Access Compliance Report

Public Rights-of-Way

(Curb Ramps)

Intersection ID: 28605	Main Street: FOX_THORNE_DR	Cross Street: MT_HOLLY-HUNTERSVILLE_RD	Location:	N
ADA ID: EE642361C85D	Ramp Type: Perp	Initial Pass/Fail: Fail	Overall Compliance: No	Severity Score: 22.5
Codes/Mitigation Info/Possible Solution		Field Measurements/Component Compliance

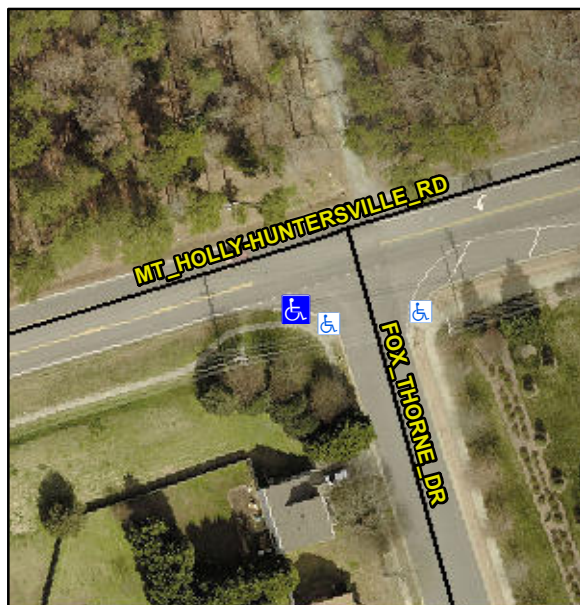
PROW/ADA:

R304.5.1, R304.2.2

Compliance	Description	Data	Compliance	Description	Data
N/A	Ramp Length (in)	48.0	No	Ramp Slope (%)	10.5
No	Ramp Width (in)	41.0	Yes	Ramp XSlope (%)	2.9
N/A	Flare Type LT	N/A	N/A	Flare Type RT	N/A
N/A	Flare Slope LT (%)	N/A	N/A	Flare Slope RT (%)	N/A
N/A	Flare Traversable LT?	N/A	N/A	Flare Traversable RT?	N/A
N/A	Landing Length (in)	N/A	N/A	DWS Provided?	N/A
N/A	Landing Width (in)	N/A	N/A	DWS Contrast?	N/A
N/A	Landing Slope (%)	N/A	N/A	DWS Length (in)	N/A
N/A	Landing X Slope (%)	N/A	N/A	DWS Full Width?	N/A
N/A	Landing Curb? (Y/N)	N/A	N/A	DWS Offset (in)	N/A
N/A	Shared Landing?	N/A			
N/A	Gutter Ponding?	N/A	N/A	Gutter Slope (%)	N/A
N/A	Gutter Lip Ht (in)	N/A	N/A	Gutter X Slope (%)	N/A
N/A	Painted X Walk1?	No	N/A	Painted X Walk2?	N/A
	X Walk 1 Direction	To N		X Walk 2 Direction	N/A
N/A	X Walk 1 Width (in)	N/A	N/A	X Walk 2 Width (in)	N/A
	X Walk 1 Slope (%)	6.8		X Walk 2 Slope (%)	N/A
	X Walk 1 X Slope (%)	4.0		X Walk 2 X Slope (%)	N/A

Possible Solutions:

Remove & Replace Entire Ramp.
